3/4.1 REACTIVITY CONTROL SYSTEMS

9705160011
PDR ADOCK 05000423
PDR

INSERT FOR PTSCR # 3-15-97

Pages 3/4 1-3 and 8 (Revised), Figures 3.1-1 to 3.1-5 (Revised) and Specification 3/4 3.5 (Added)

FIGURE 3.1-1
REQUIRED SHUTDOWN MARGIN FOR MODE 3 WITH FOUR LOOPS IN OPERATION

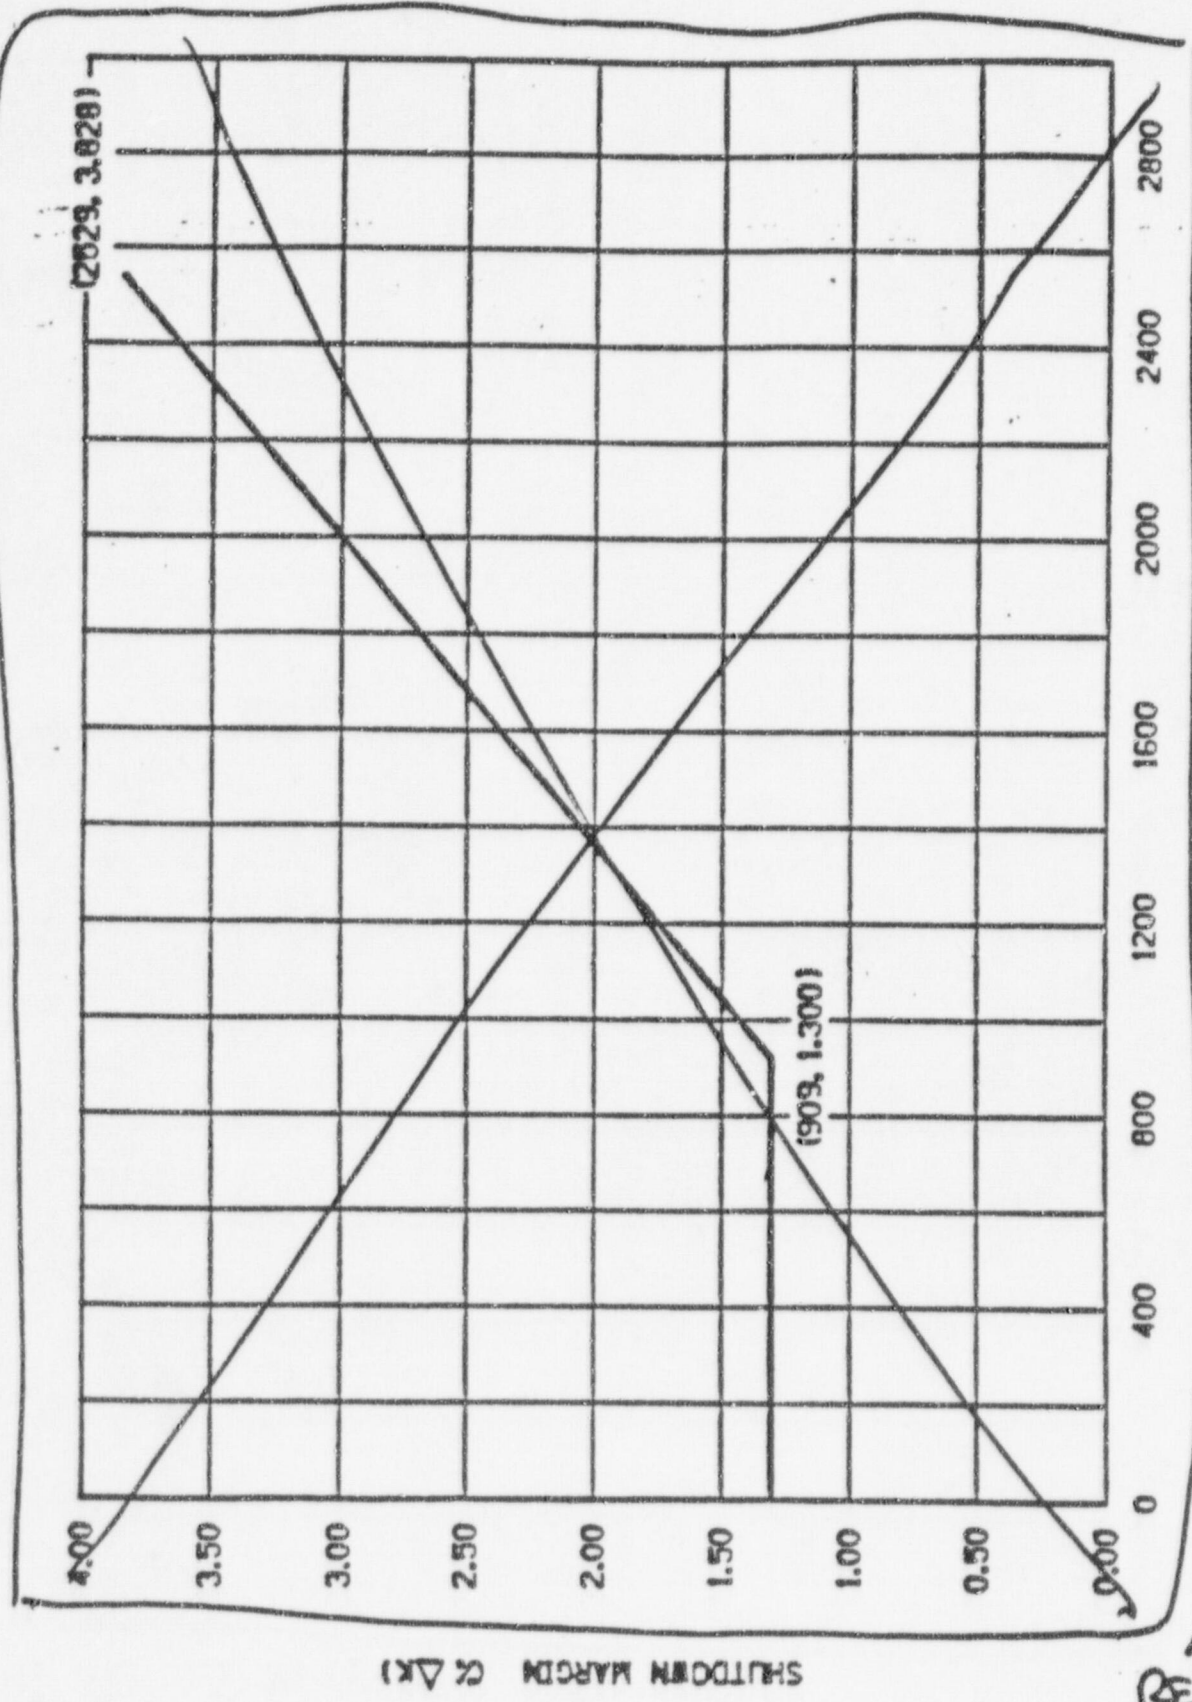
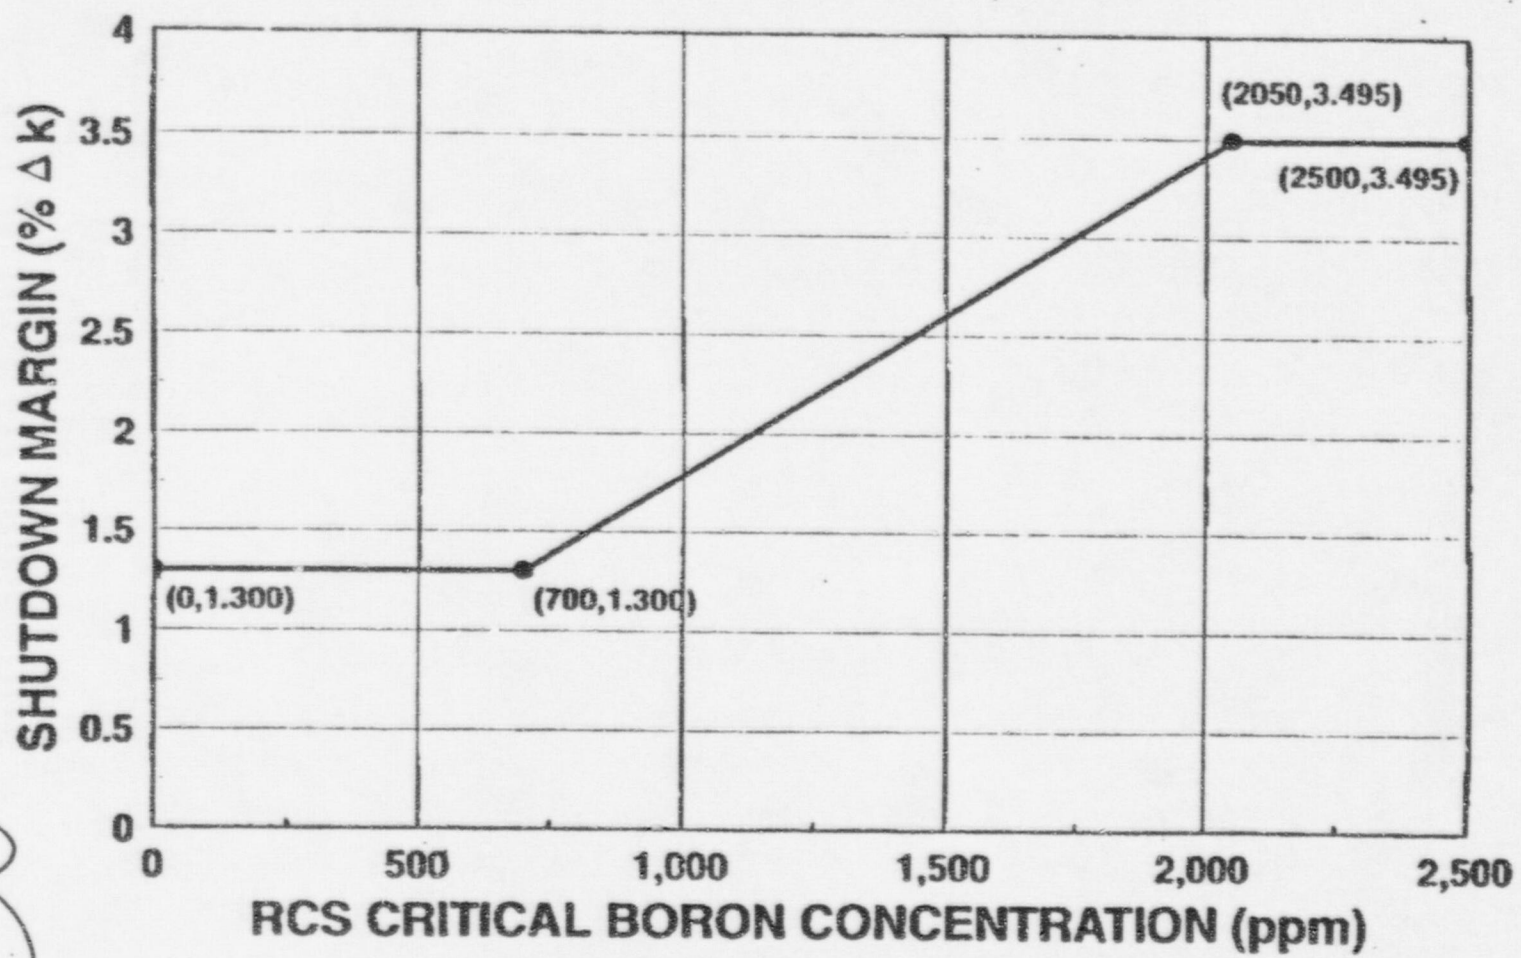
DELETED

AND

REPLACED

BY: INSERT

ppm for Mode 3 (to be added to the requirement in Figure 3.1-1 and 3.1-2) and 350 ppm for Modes 4 and 5 (to be added to the requirement in Figures 3.1-3, 3.1-4 and 3.1-5).

- More limiting Shutdown Margin requirements in Figures 3.1-1 to 3.1-5 are added which allow for the SMM to be considered operable for lower count rates in Modes 3, 4 and 5.
- Additional boration values included in Specification 3.3.5 which are to be applied to the Shutdown Margin requirements in Figures 3.1-1 to 3.1-5. The addition of Shutdown Margin above the requirements in the Figures allows the SMM to be considered operable for count rates which are lower than allowed by implementation of only the Figures 3.1-1 to 3.1-3-5 requirements.

FIGURE 3.1-2
REQUIRED SHUTDOWN MARGIN FOR MODE 3 WITH THREE LOOPS IN OPERATION

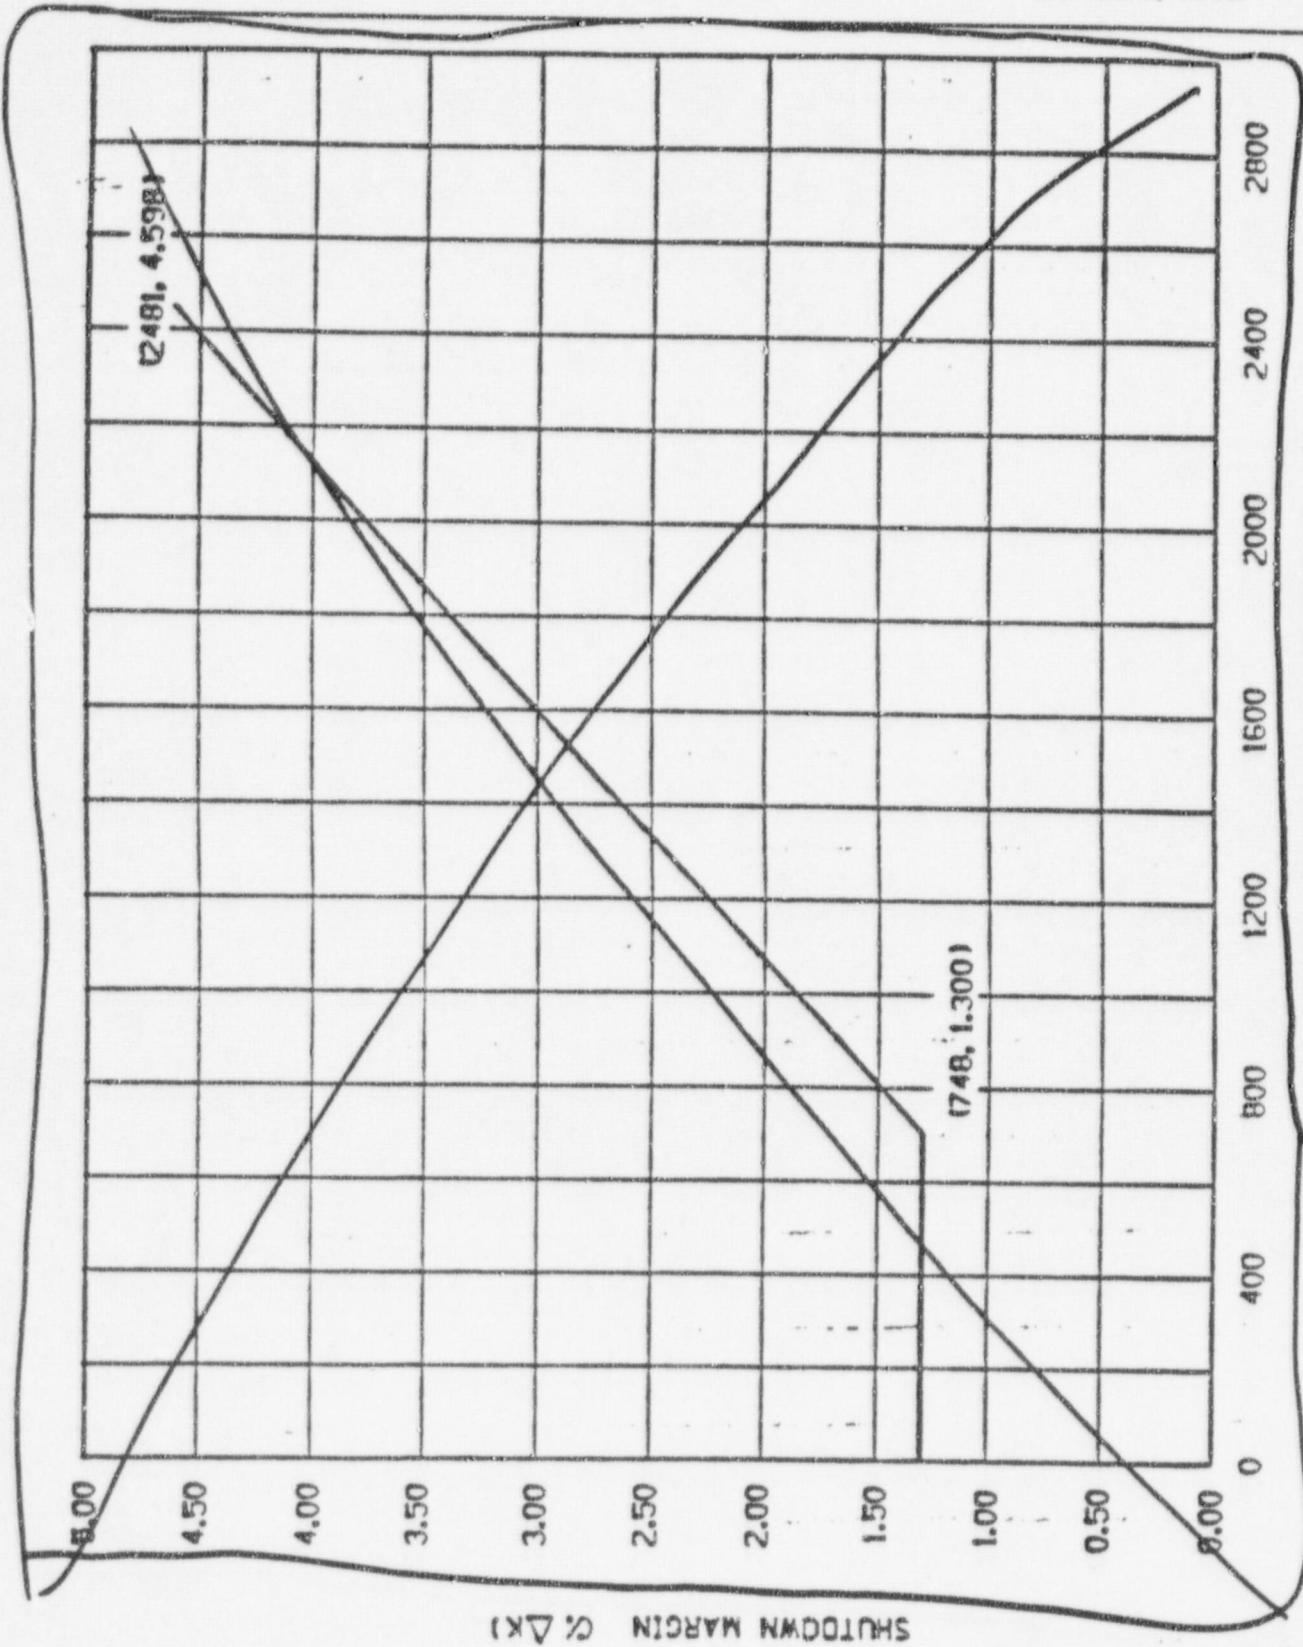
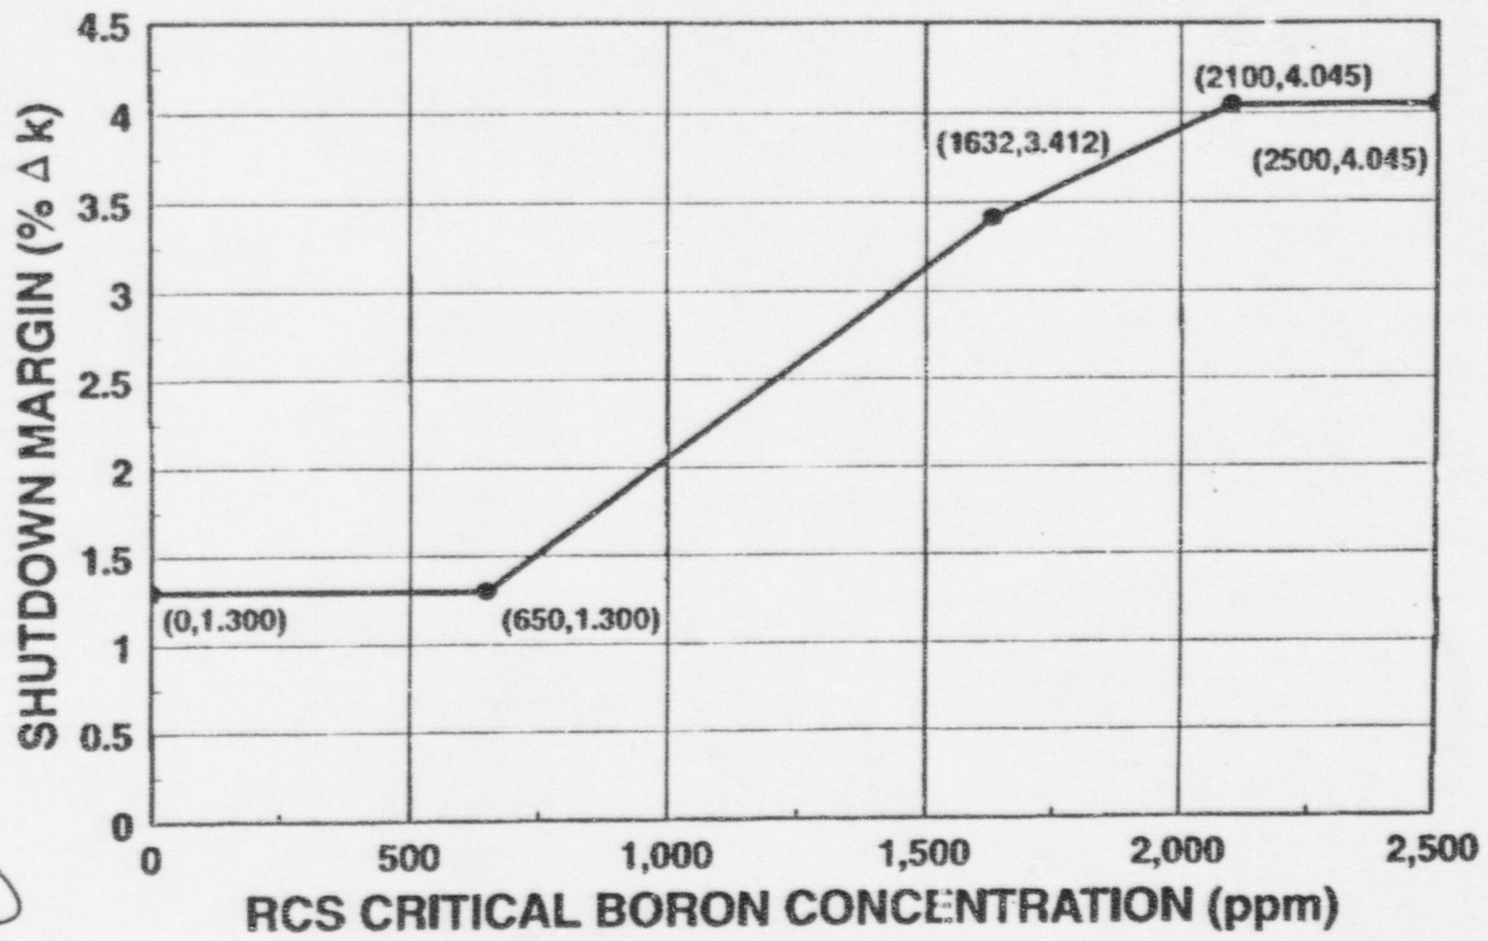
DELETED AND REPLACED BY: INLET 3.1-2

FIGURE 3.1-3
REQUIRED SHUTDOWN MARGIN FOR MODE 4

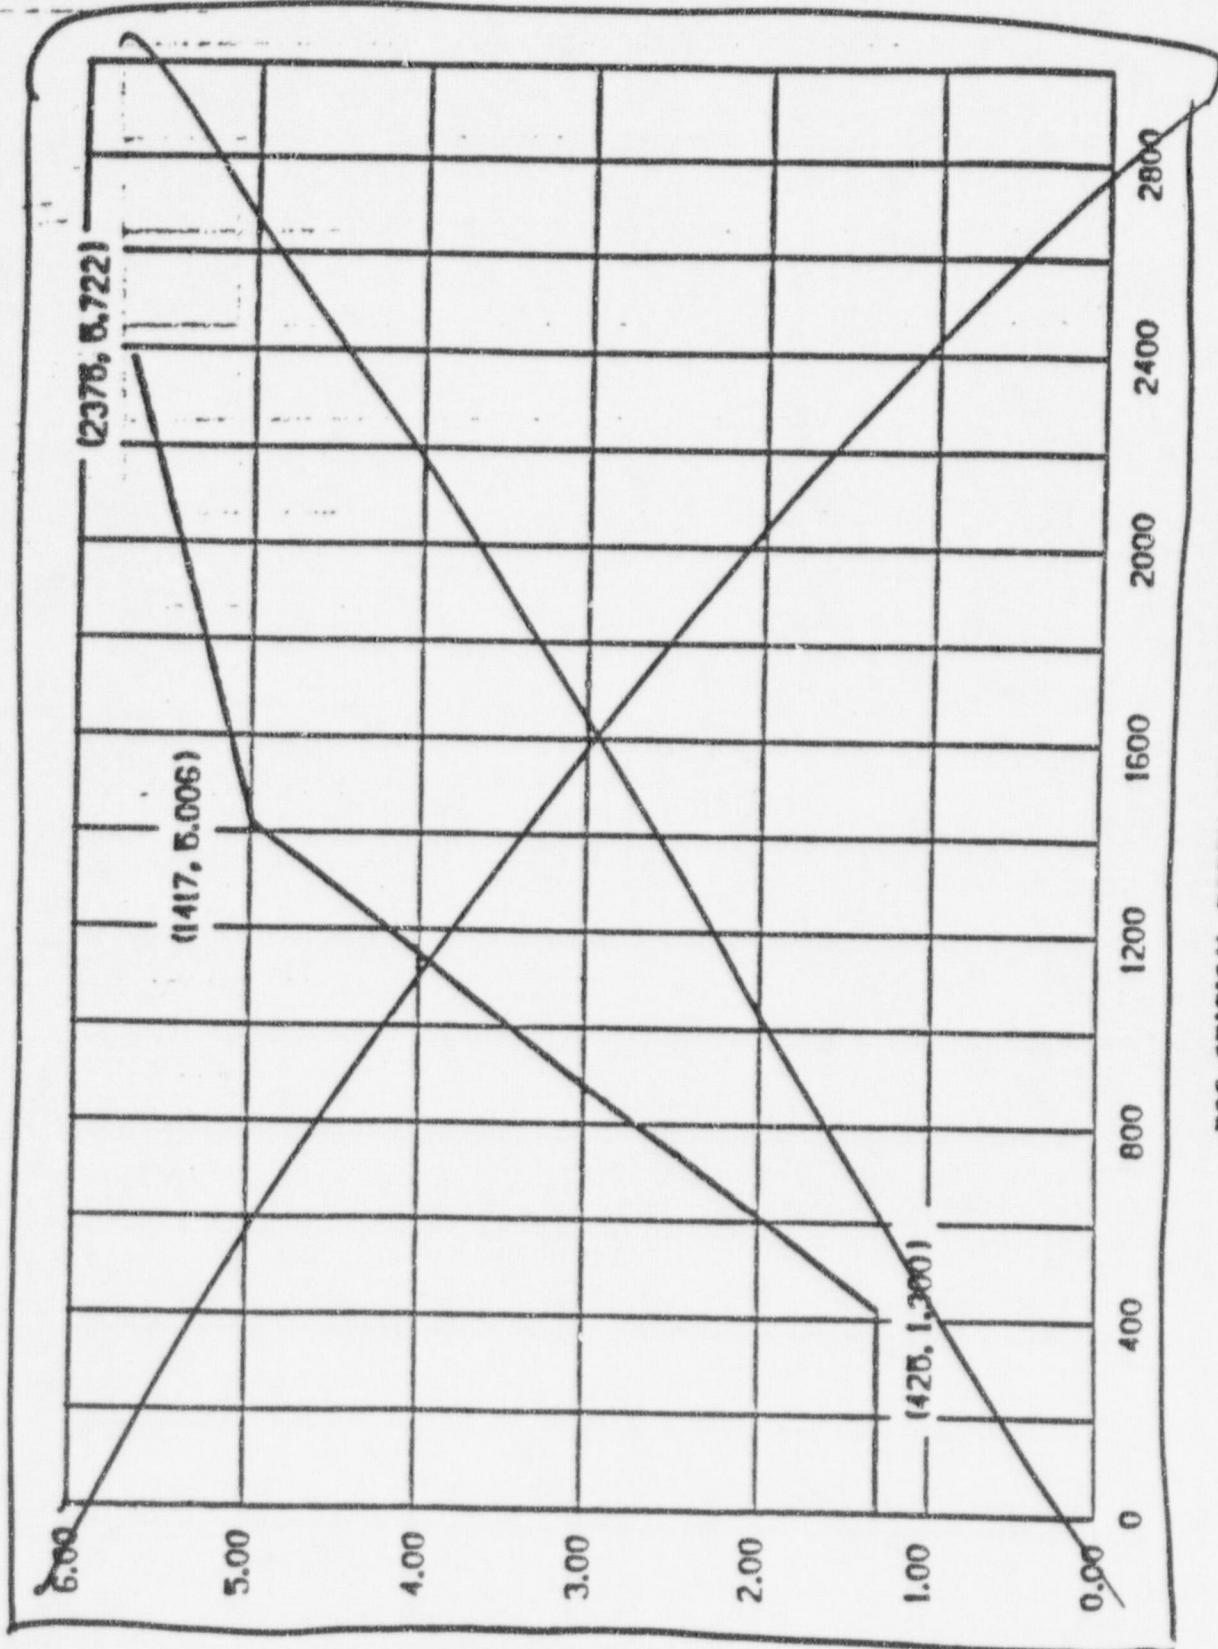
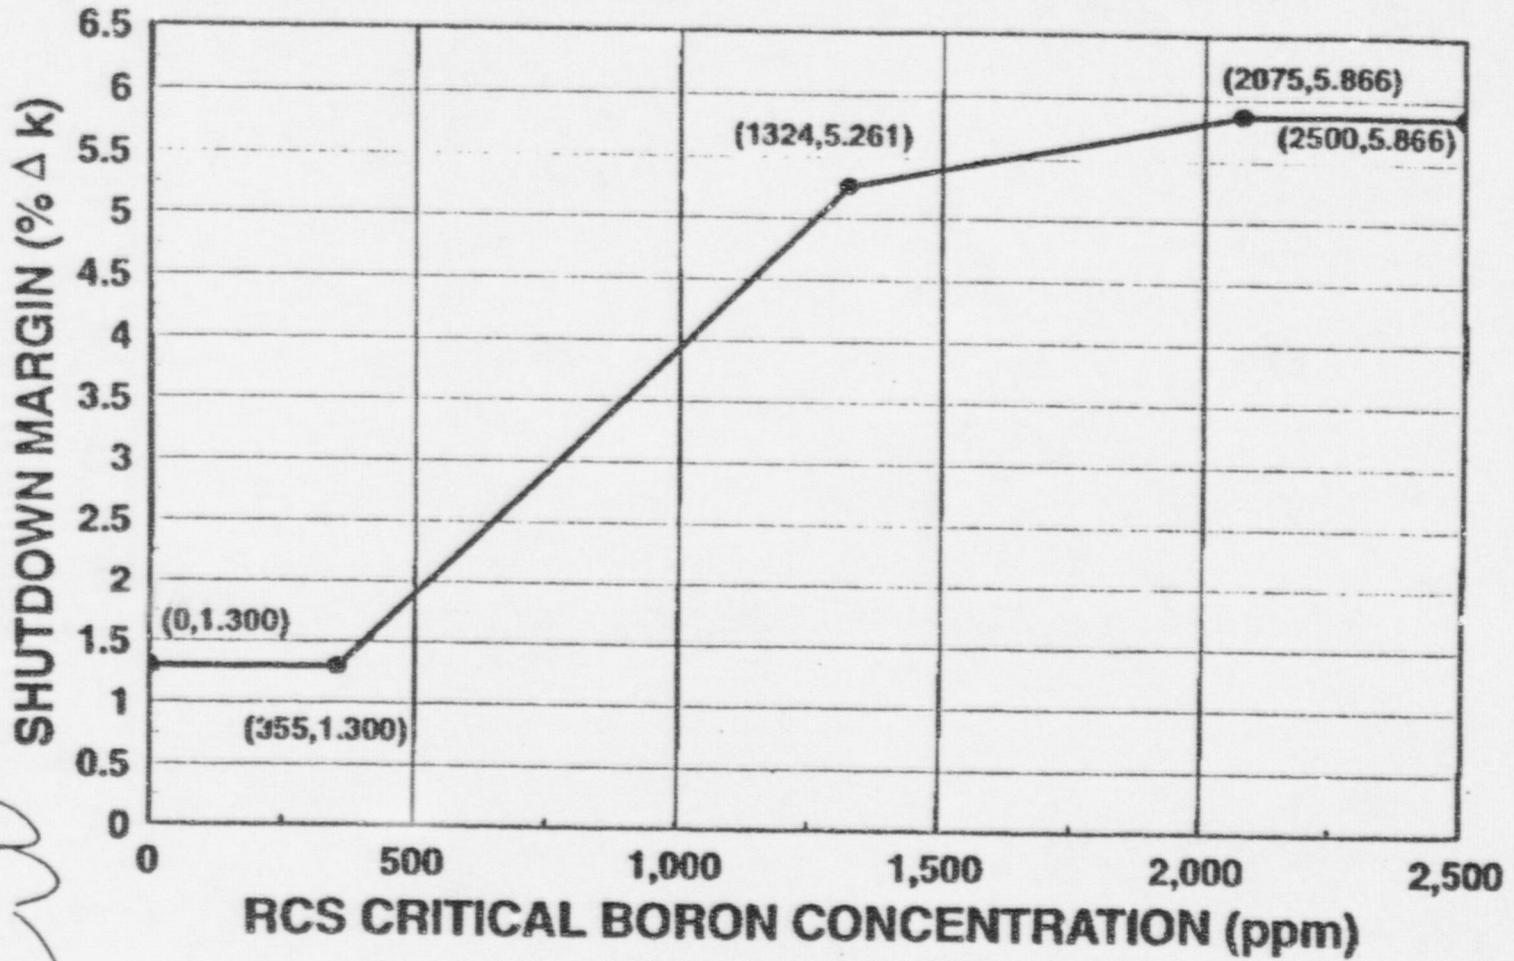
DELETED AND
REPLACED BY :

INSERT 3.1-3
AMENDMENT NO. 60
